SUBJECT: **REVISION "A" TO ALERT SERVICE BULLETIN 412-06-119:
MODIFICATION TO AIR CONDITIONER SYSTEM MADE BY AIR
COMM CORPORATION AND INSTALLED UNDER F.A.A.-APPROVED
SUPPLEMENTAL TO TYPE CERTIFICATE (STC) # SR00066DE.**

NO. 412-06-119

Service Bulletin: SB412-306; Bell 412 Air Conditioner System

Subject: Installation of Compressor Safety Strap.

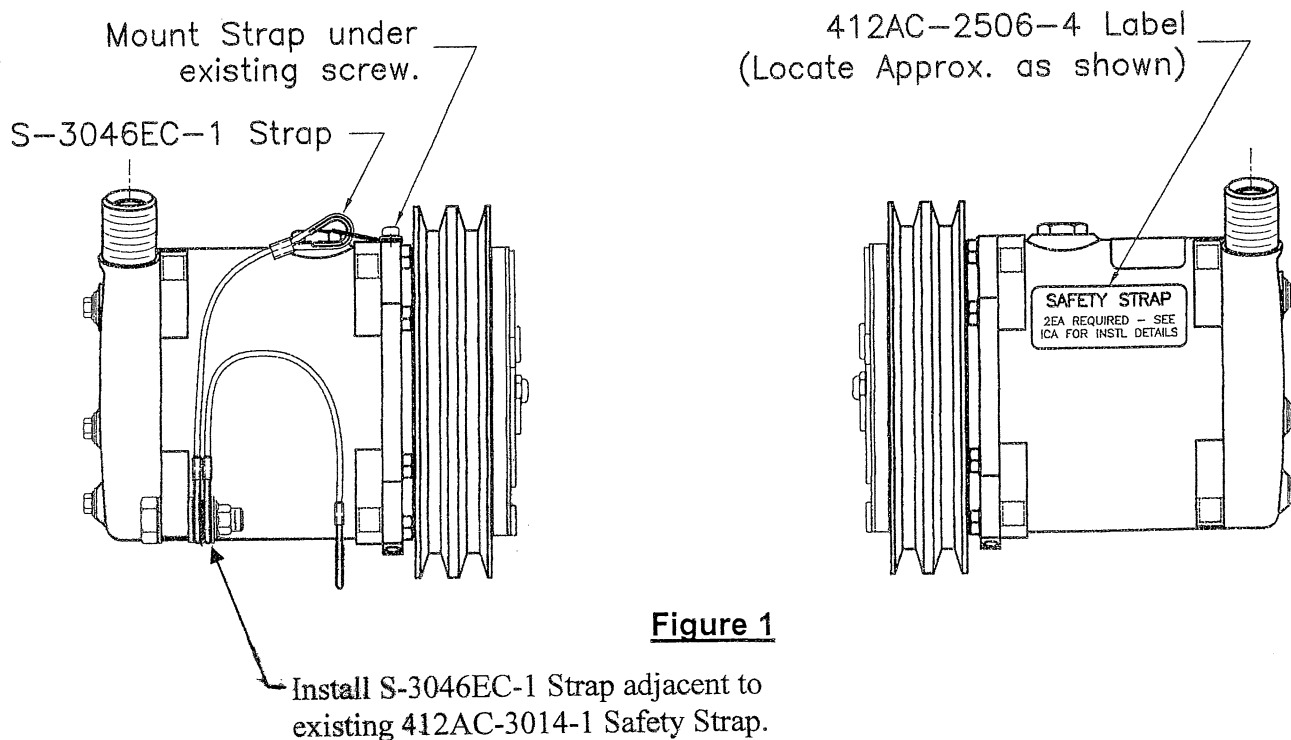
Due to a recent Compressor failure a Safety Strap has been added to the 412AC-3542-2 Compressor Assembly. This strap will retain the Compressor Clutch Assembly and/or the Compressor End Plate in case of failure.

The Purpose of this bulletin is to explain the modifications necessary to install the Safety Strap on the Bell 412 Air Conditioner Compressor.

Install S-3046EC-1 Safety Strap and 412AC-2506-4 Label as shown in Fig 1.7

Revision A: To correct typographic error in Figure 1 text.
